Product Change Notification

1. ECR #: 221400
Notification #: 672

3. Series:
• 240 - 240 ST JACK FOR COMPRESSION MOUNT

4. Part #'s Affected
• 240-J-P-EP-ST-CM-X-X

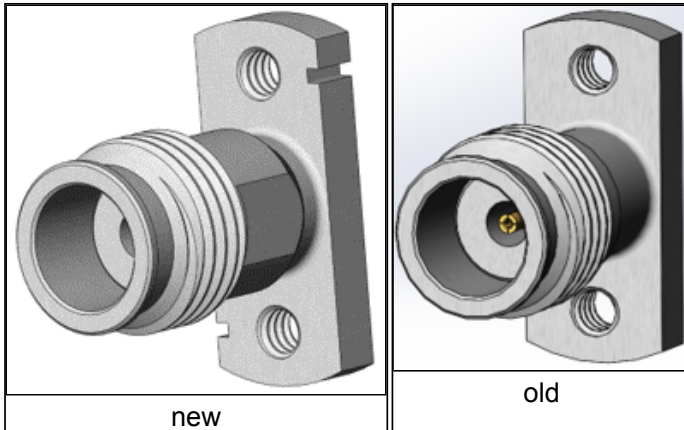
5. Description of Change:
We added two grooves on our body for PCB mounting alignment and a flange for our custom wrench to prevent rotation.

6. Method of Identifying Change
Two grooves and a flange on the new body

7. Reason for Change:
For better alignment onto the PCB

8. Impact of Change on Form, Fit, or Function:
• Form - Form change
